# DEVELOPMENT REVIEW BOARD REPORT

MEETING DATE: February 16, 2006

CASE NUMBER/ PROJECT NAME	<b>71-DR-2005 Classic Car Spa</b>		
LOCATION	22111 N. Scottsdale Road		
REQUEST	Request approval of a site plan & elevations for a new car wash facility with automotive services.		
OWNER	Strategic Asset Acquisition LLC 480-993-4211	ENGINEER	Norman Engineering 602-371-0397

SITE PLAN

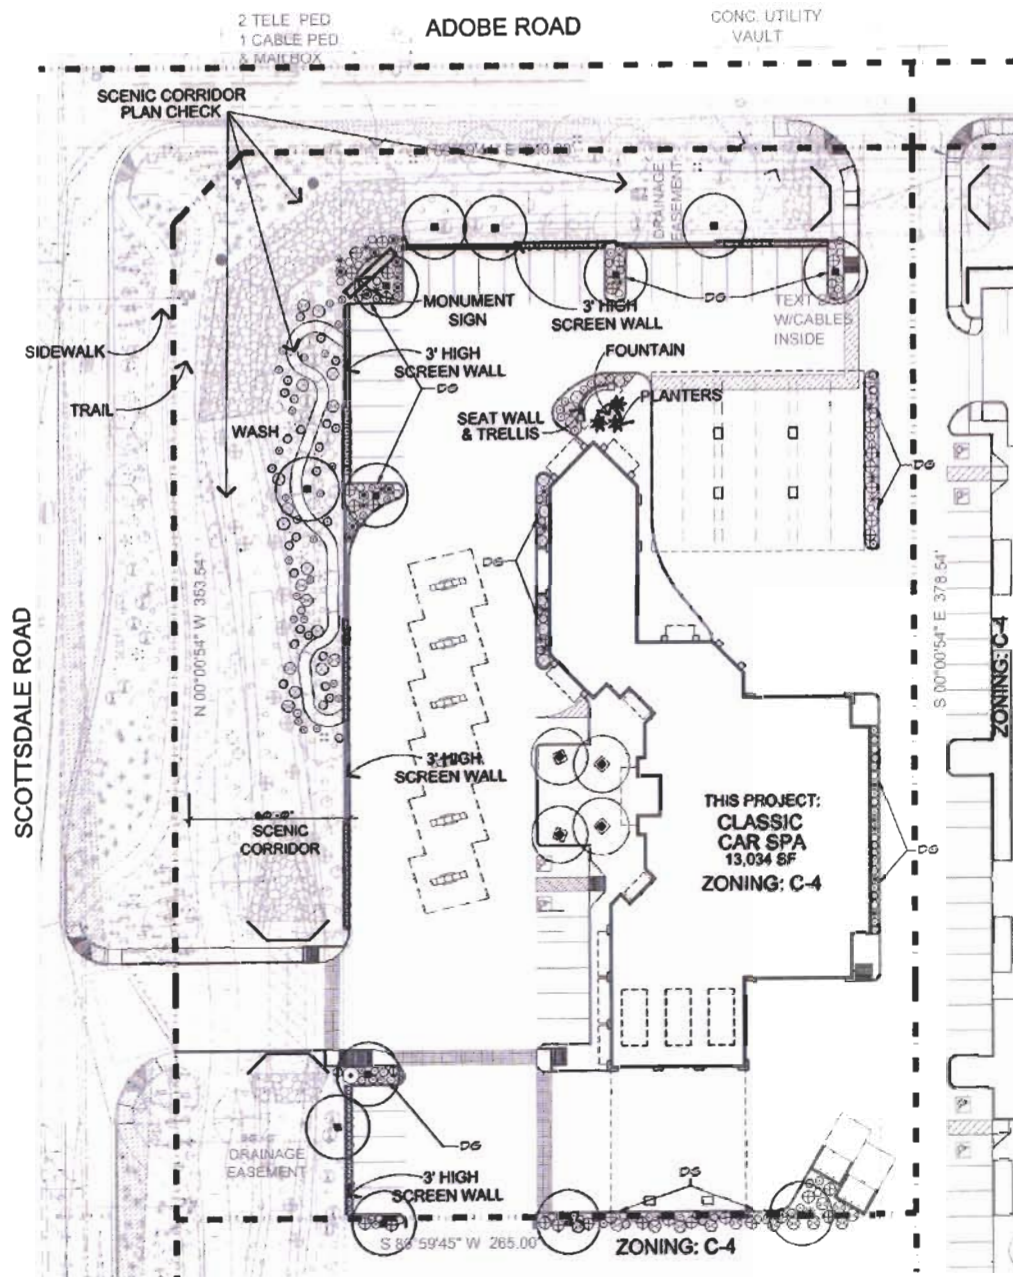
Comments were made regarding color and design during the January 10, 2005 City Council meeting for the Use Approval. Since that meeting the applicant has worked with staff to revise the entrance to the building, stack the gas canopies, revise color elevations depicting colors that are more compatible with the desert, and provide additional landscaping along the Scottsdale Road frontage.

WEST ELEVATION

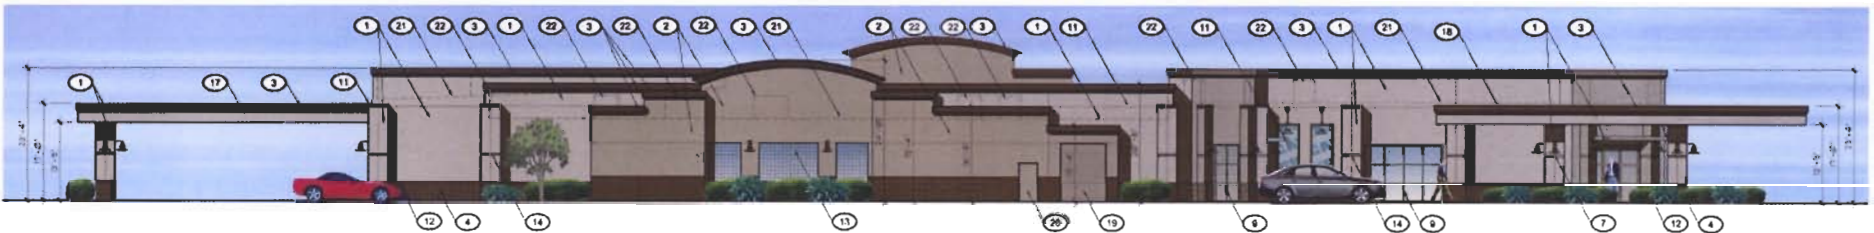
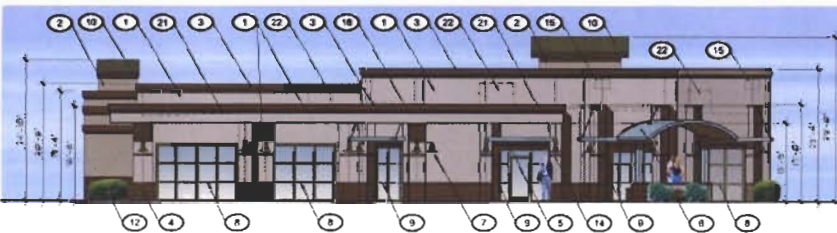
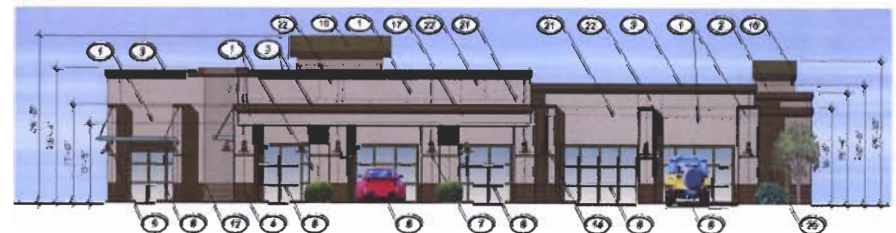
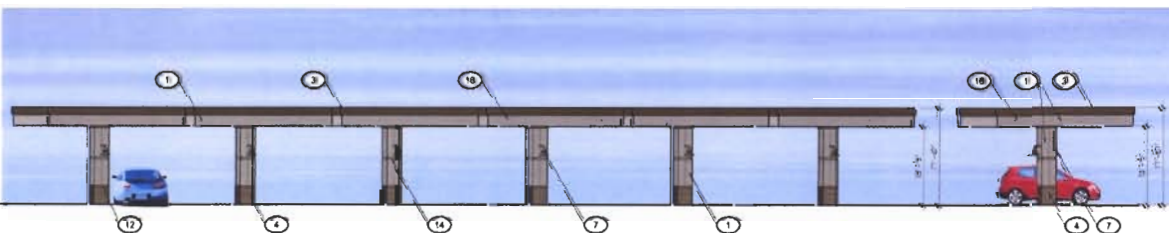
13. Tinted, metallized, or coated glazing shall not have a reflectance of outdoor visible light exceeding 17%. Note or specify accordingly on the elevation drawing.

14. Windows shall be recessed no less than 50% of wall depth from external wall face, excluding external detailing.
15. Spandrel glazing, if used, shall have an external appearance matching vision glazing.

16. Doors and store front systems with doors shall be recessed no less than 30% of wall depth from external wall face, excluding external detailing.
17. Service entrance sections shall be internal, fully screened by walls, or recessed into the face of building so that it is flush with the immediately adjacent surface. If exterior, SES panels shall be painted to match the adjacent building walls. They shall also be located to minimize visibility from a public vantage point (the scenic corridor). Revise drawings to indicate preliminary locations of all SES panels.
